<b><u>AGENDA PACKET</u></b>		
<b><u>NOVEMBER 20, 2018 MEETING</u></b>		
	<b><u>CAL#</u></b>	<b><u>PAGE</u></b>
<b><u>AGENDA</u></b>		<b>4</b>
<b><u>OAKRIDGE COMMONS, 450 OAKRIDGE COMMON, SOUTH SALEM</u></b>	<b>Cal #08-17PB</b>	<b>Cal#16-17SW</b>
Kellard Sessions Review Memo, dated November 14, 2018		<b>5</b>
CAC Review Memo, dated November 8, 2018		<b>8</b>
Public Hearing materials		<b>9</b>
Oakridge Carwash Anticipated Carwash water use calculations, February 7, 2018		<b>10</b>
Emails from Westchester County Health Dept., dated July 27 and October 15, 2018		<b>15</b>

**AGENDA**

**Tuesday, November 20, 2018**

RE: Oakridge Commons Shopping Center – Car Wash  
450 Oakridge Commons  
Sheet 49, Block 9829, Lot 10

SP/2C

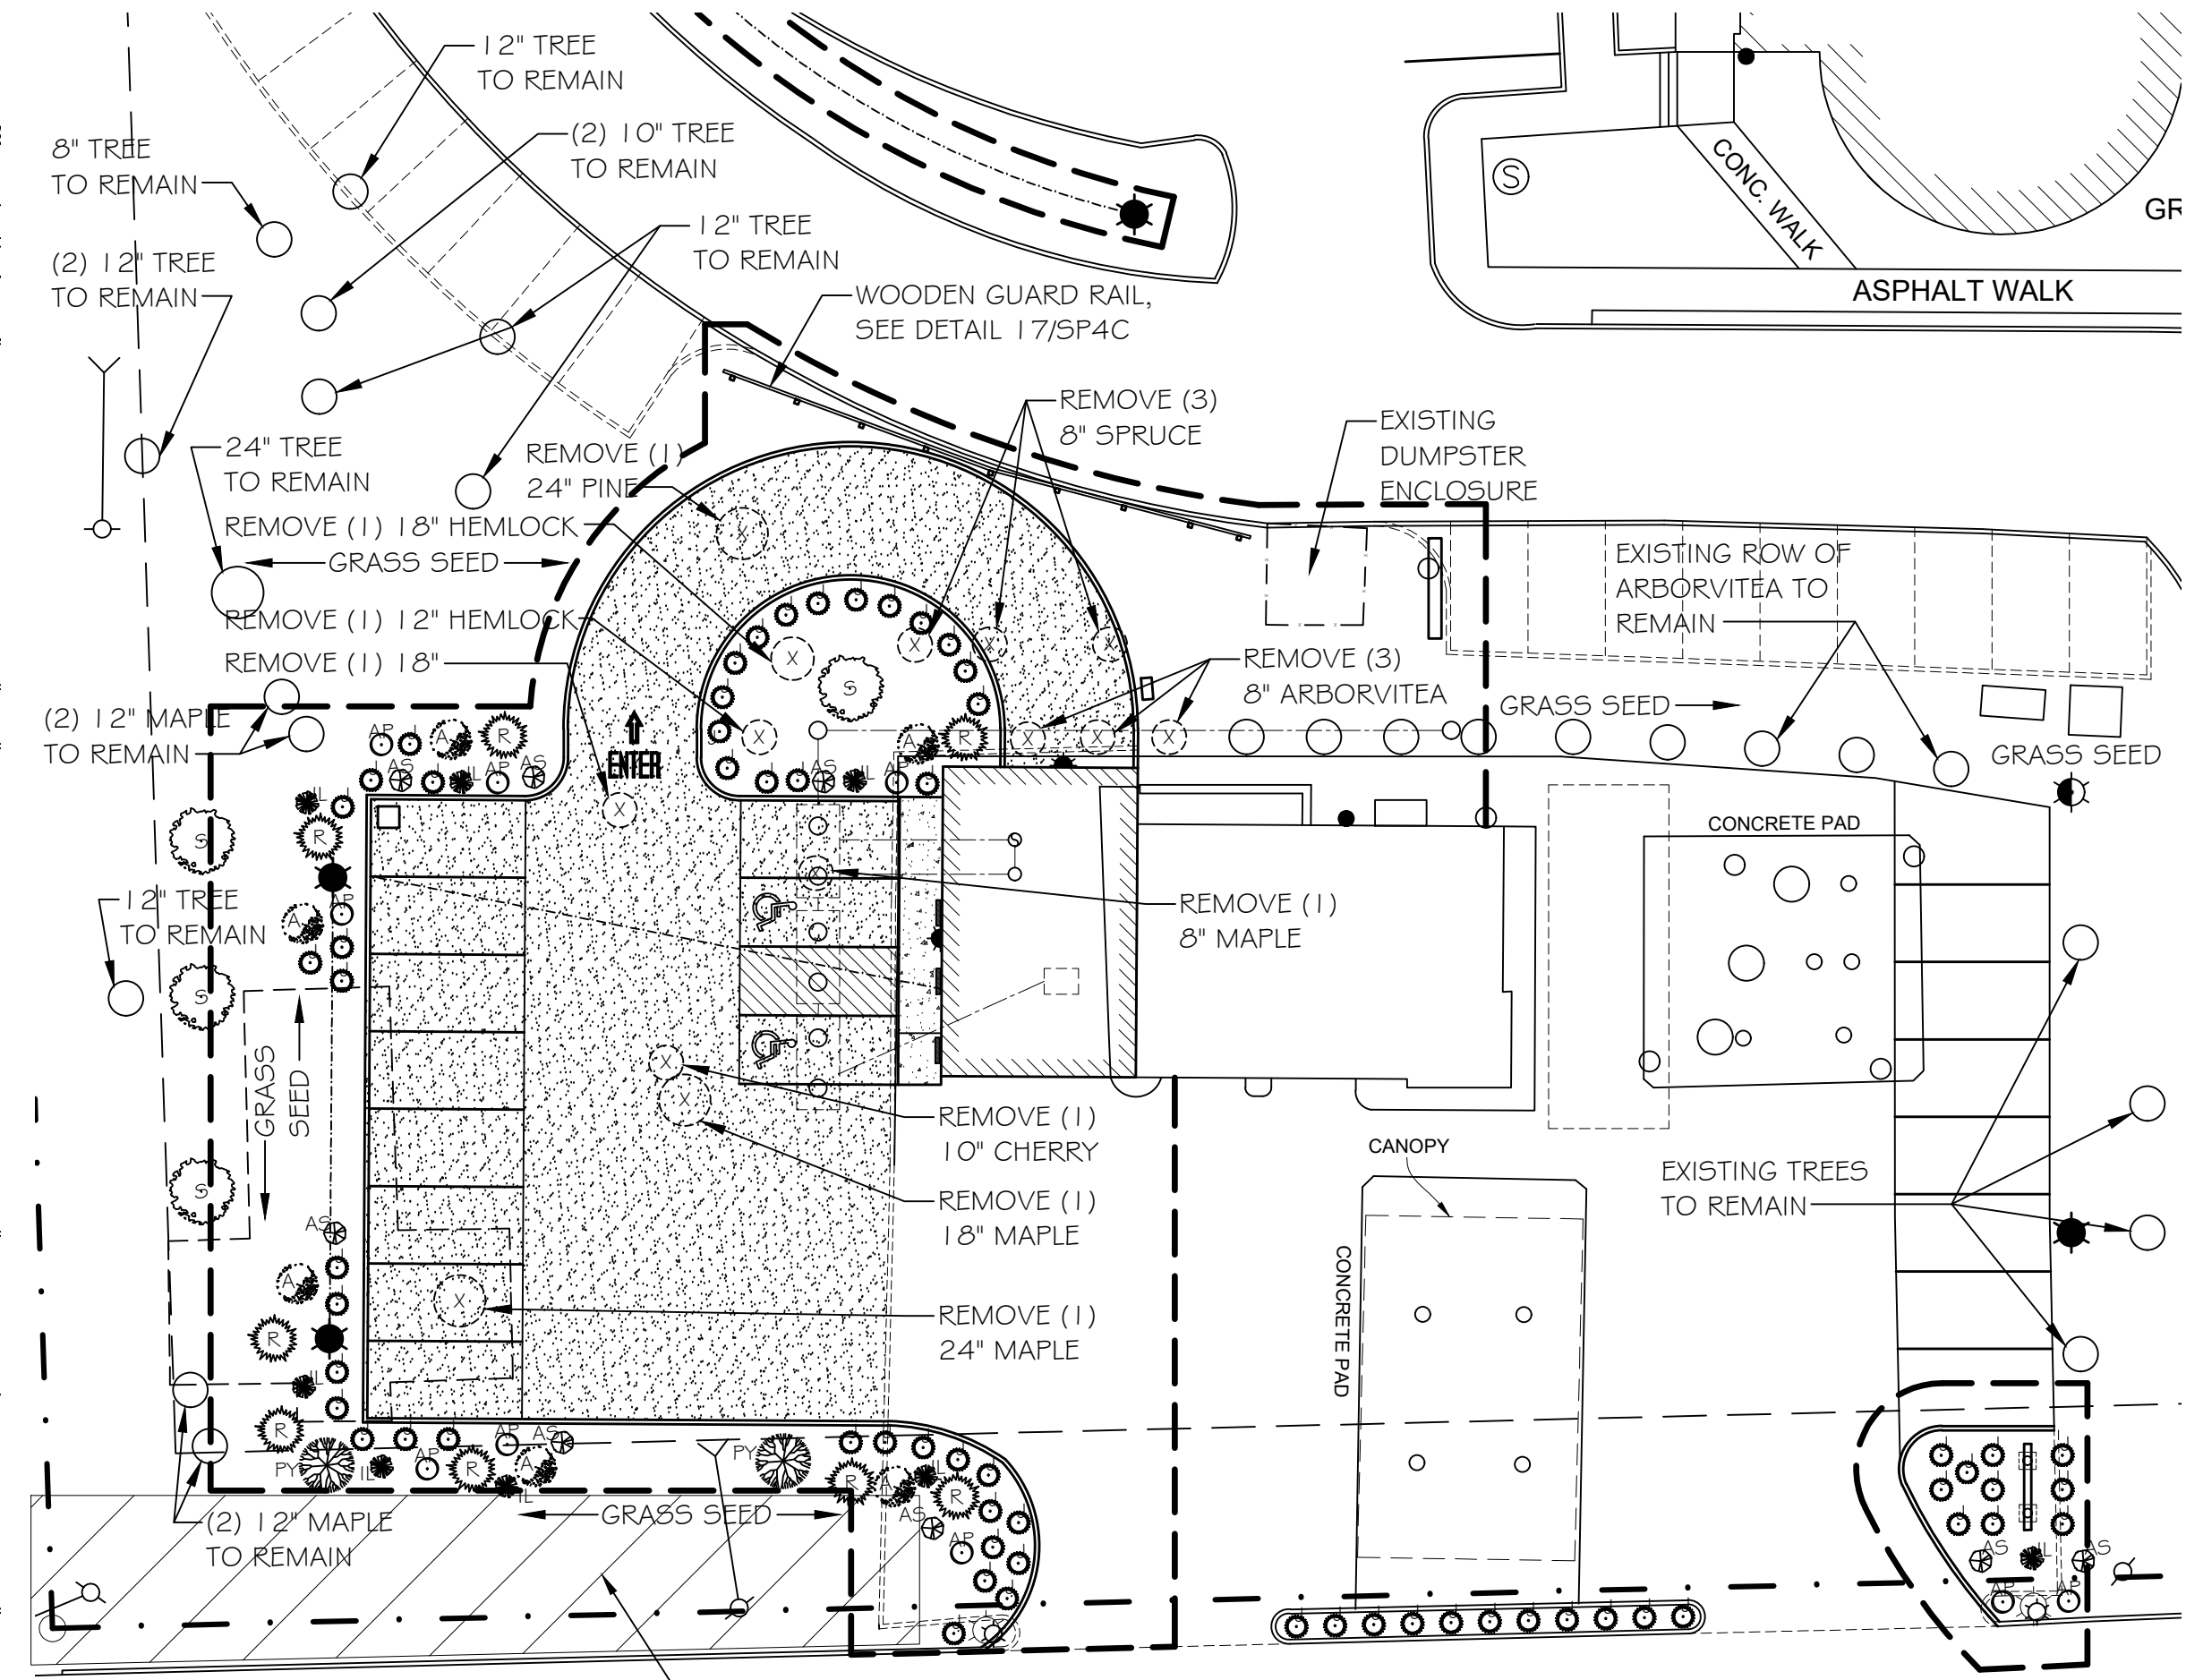
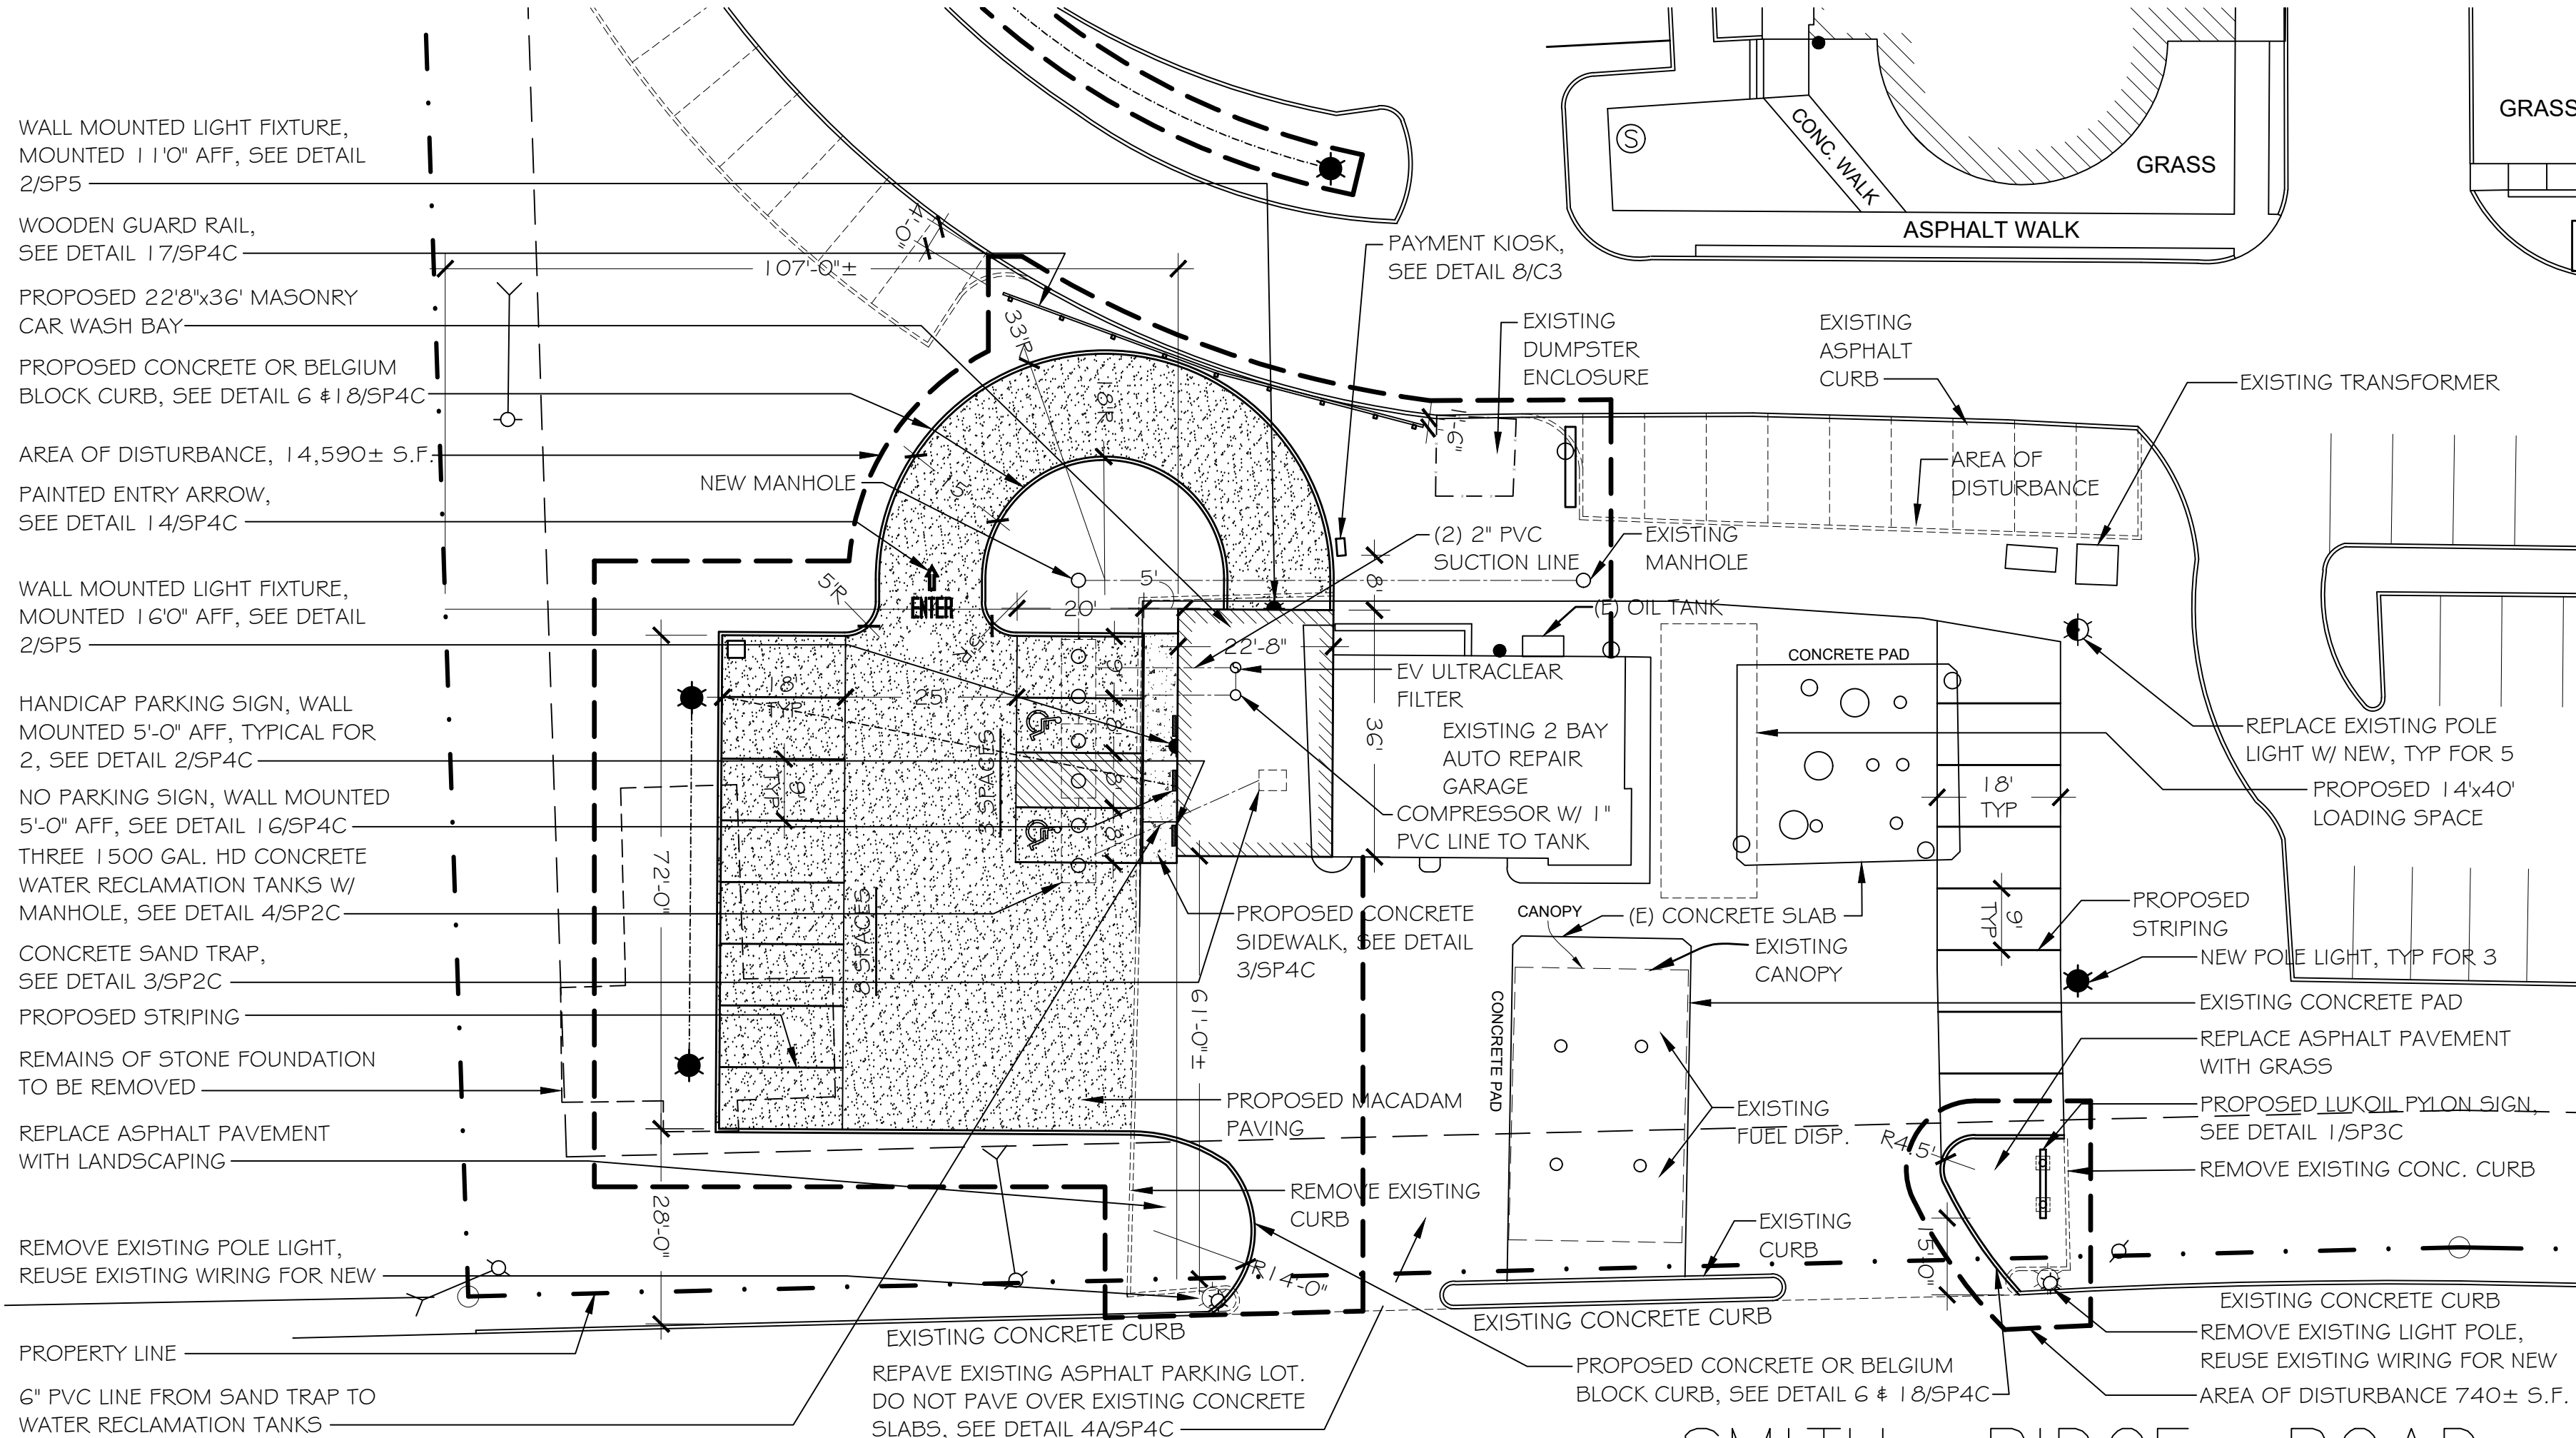
3. This office agrees with the sight distance improvements recommended by Tim Miller Associates, Inc., which have been incorporated into the site plan.

- 2) There was a question about sight distance at the existing gas station entrance. We have included the response letter from Tim Miller Associates dated 10/31/18. The letter includes the recommendation to remove the existing overgrown vegetation within 5' of the road, which is shown on drawing SP2C. Otherwise, there is no site distance issue.
